"DIMENSION@" 600 PBX
(FORMERLY "DIMENSION" 400E PBX)
SYSTEM DESCRIPTION

1.001 This addendum supplements Section 554-105-100, Issue 7. Place this pink sheet ahead of Page 1 of the section.

1.002 This addendum is issued for the following reasons:

Fig. 40.1 — Voice Store and Forward Interface

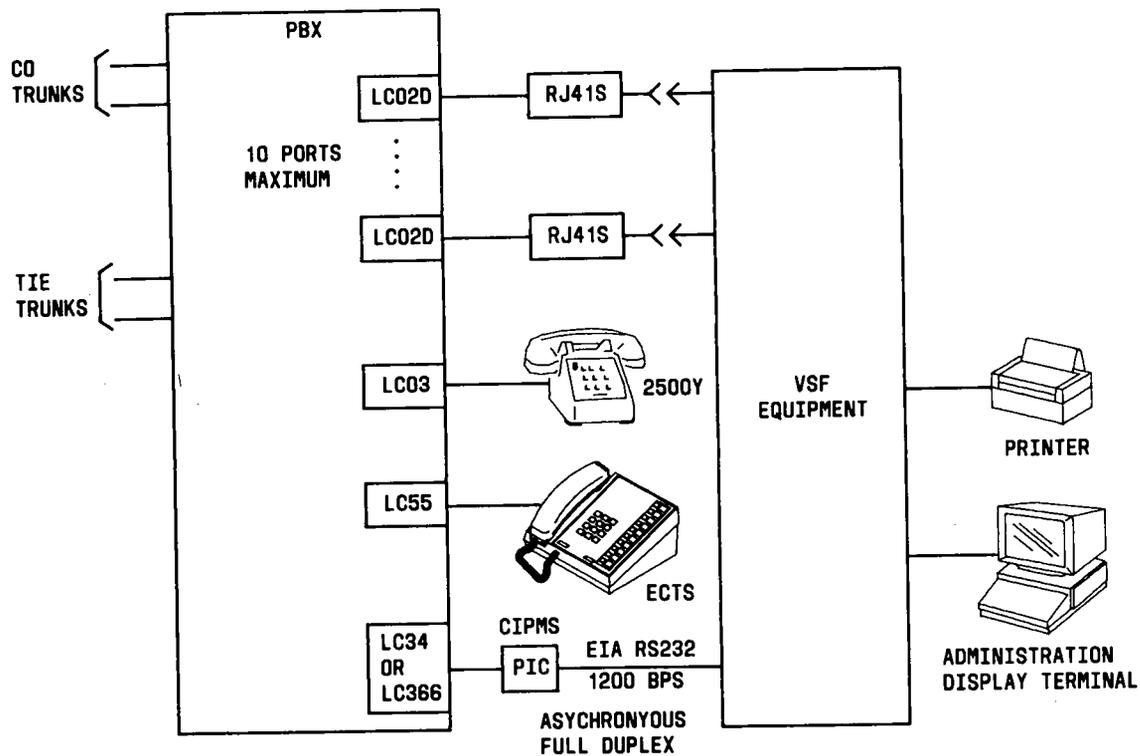
2.003 On Page 98 after paragraph 3.355, add the following new feature description.

VOICE STORE AND FORWARD (VSF) INTERFACE

3.355.1 This feature, available with FP11, allows an interface of the PBX with a computer having VSF capabilities. These capabilities consist of the following:

3.355.2 Figure 40.1 illustrates the VSF interface.

Voice paths from the PBX are via LC02D circuit packs. An RJ41S jack is used as the interface point between PBX wiring from the LC02D and the VSF equipment. The Customer Interface for Property Management System (CIPMS) feature is used as the mechanism by which a VSF subscriber is alerted concerning the presence of a message. The PIC shown can be located no more than 300 meters (1000 feet) from the VSF equipment without range extension. A maximum of four range extensions of 750 meters (2500 feet) each are permitted. The status inquiry time-out interval used for CIPMS between the PBX and VSF equipment is 6 minutes instead of the 10-second time-out used for the Property Management System interface to the PBX.
